Department of Water Resources

Date: February 2, 2010
To: Aaron Marshall
From: Mike McVay 
cc: Sean Vincent and Rick Raymondi
Subject: Evaluation of Southeast Idaho Energy water right transfer

Figure 9. Graph of the net effects of the proposed well on the Snake River reaches above Milner assuming full transfer volume.

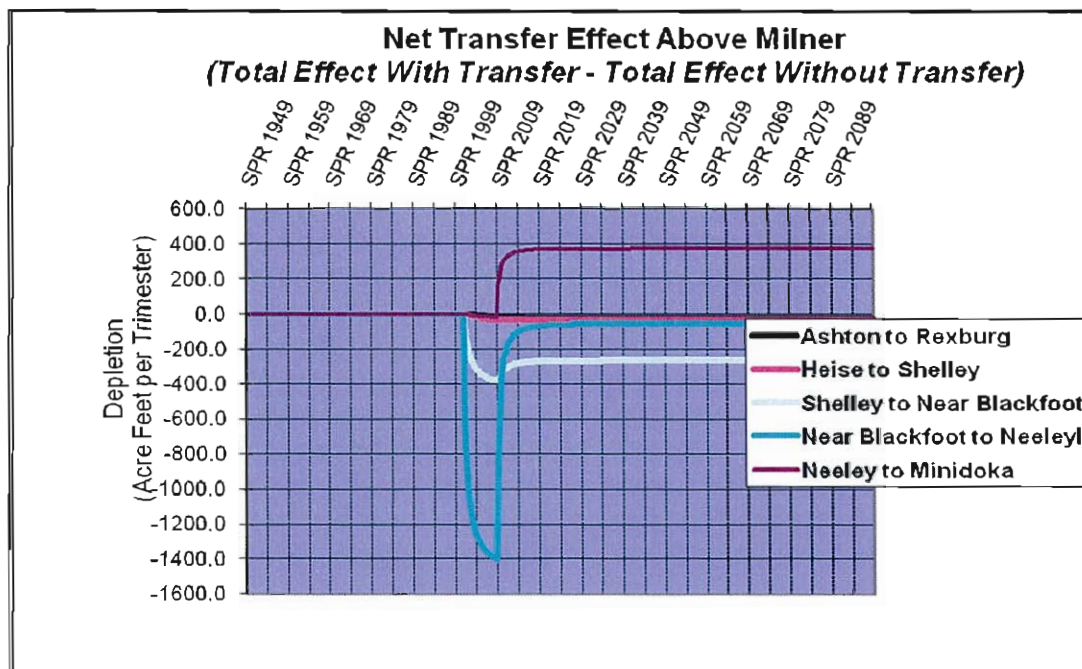
Using the requested transfer volume of 6,153.8 AF/yr, negative effects calculated by the transfer tool are greatest in the Neely-to-Minidoka reach of the Snake River with depletions of 372.8 AF/trimester. This analysis also predicts significant gains for the Shelley-to-Near Blackfoot (264.0 AF/trimester), Near Blackfoot-to-Neeley (53.3

AF/trimester), Heise-to-Shelley (29.13 AF/trimester), and Ashton-to-Rexburg (24.22 AF/trimester) reaches (Figure 9, Table 2).

Figure 10. Graph of the net effects of the proposed well on the Snake River reaches above Milner assuming 17.6% reduction in transfer volume.

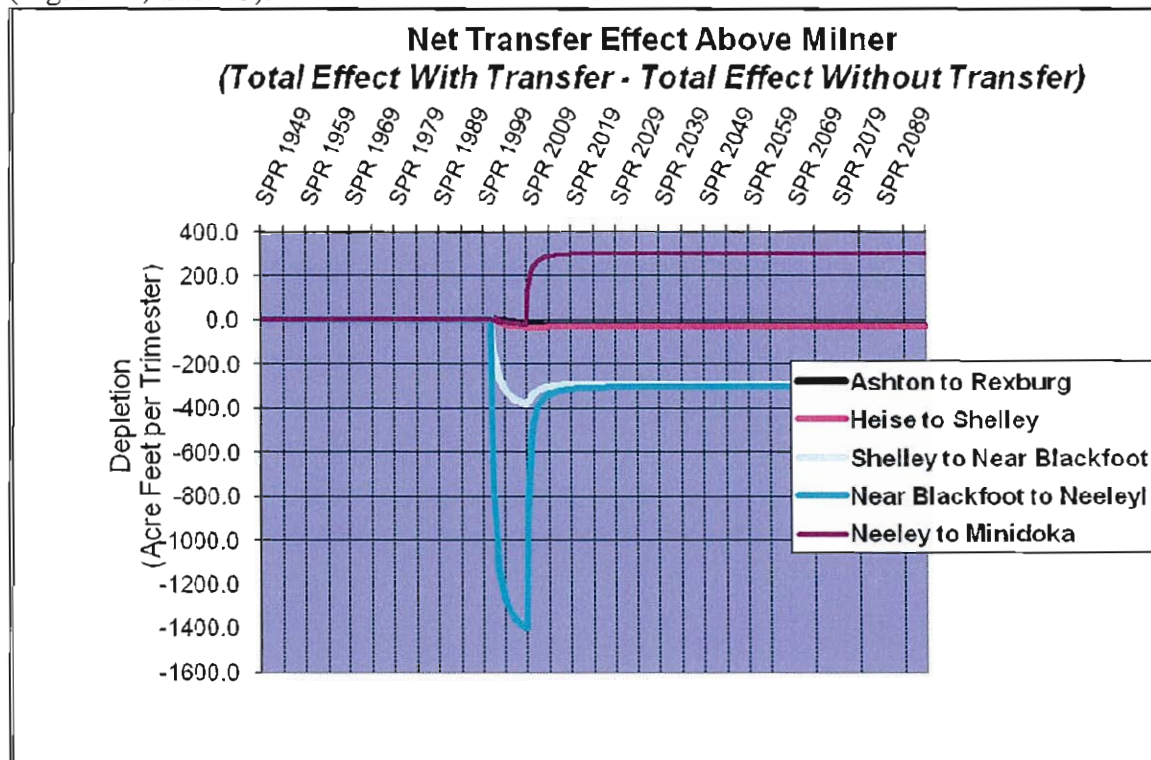
Using the reduced pumping volume of 5,070 AF/yr, the Transfer Tool calculates a *gain* of 302.9 AF/trimester along the Near-Blackfoot-to-Neeley reach, and a *depletion* of 302.2 AF/trimester along the Neely-to-Minidoka reach of the Snake River. This analysis also predicts significant gains for the Shelley-to-Near Blackfoot (290.3 AF/trimester), Heise-

to-Shelley (32.2 AF/trimester), and Ashton-to-Rexburg (26.9 AF/trimester) reaches (Figure 10, Table 3).

The calculated effect due to the transfer on the combined Near-Blackfoot-to-Minidoka reach is a *gain* of 0.7 AF/trimester. Assuming that dam operations can be altered to administer this transfer, this approach appears to mitigate flow in the combined Neeley-to-Minidoka reach.

Figure D1. Estimated drawdown vs. time for wells located 0.5 ft, 5,280 ft, and 26,400 ft from the SEI site.

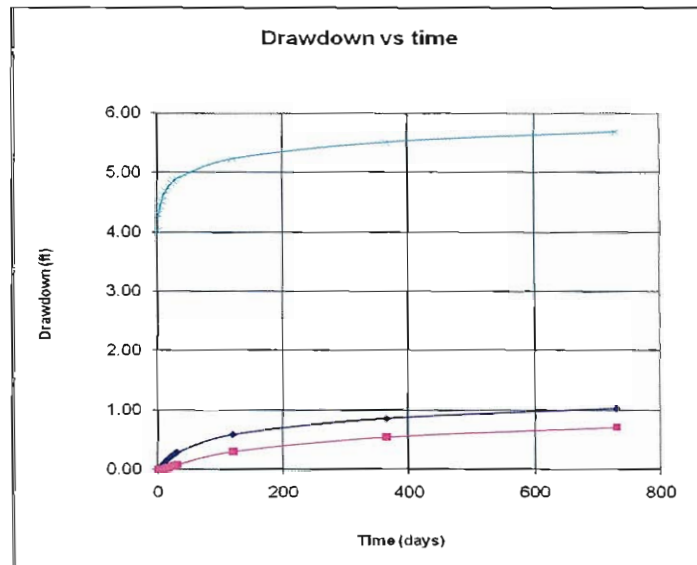
Below is presented the IDWR Theis analysis of impacts due to pumping the SEI wells. The projected drawdown at a point one mile away from SEI, due to pumping 2000 gpm continuously for 60 days and 365 days, are 0.5 ft and 1.01 ft, respectively (Table D2, Figure D1).
